SERVICE No. 1026 BULLETIN

DATE: November 5, 1998 (S/M)

Distribution of Parker Hannifin Airborne Service Letter 48, "Inspection/Replacement of dry air pump flexible couplings".

Service Letter Number: 48

FIGURE 1

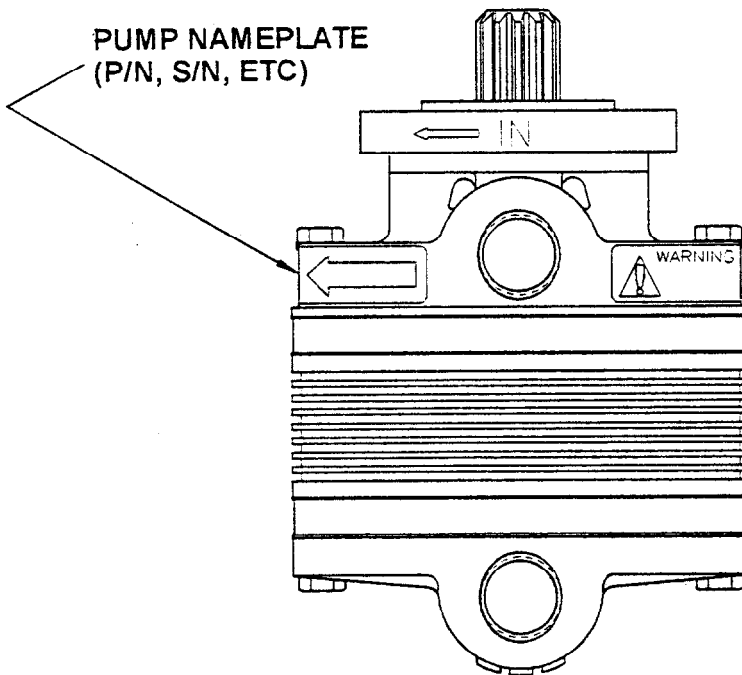
Applicability: Airborne dry air pumps, conversion kits and flexible coupling kits with the following part numbers/serial numbers which have not been inspected per this service letter as identified in step number seven of the procedure listed below. These components were shipped from Airborne between 1/1/98 and 10/13/98. Refer to Figure 1 for location of part number/serial number nameplate.

FIGURE 2

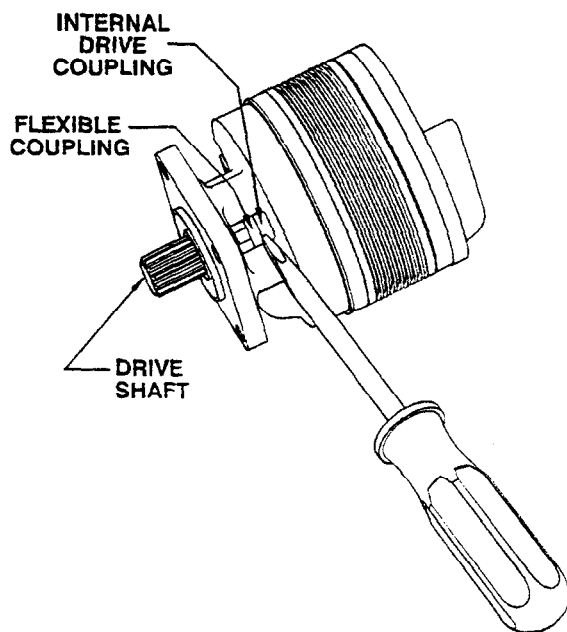
- 1) Remove dry air pump from engine accessory pad per instructions provided by the airframe manufacturer in the appropriate maintenance publication.
- 2) Insert a screwdriver or similar tool between the flexible coupling assembly (2-piece) and the pump's internal drive coupling. Remove the flexible coupling assembly from pump, taking care not to damage any of the eight drive pins. Refer to Figure 2.
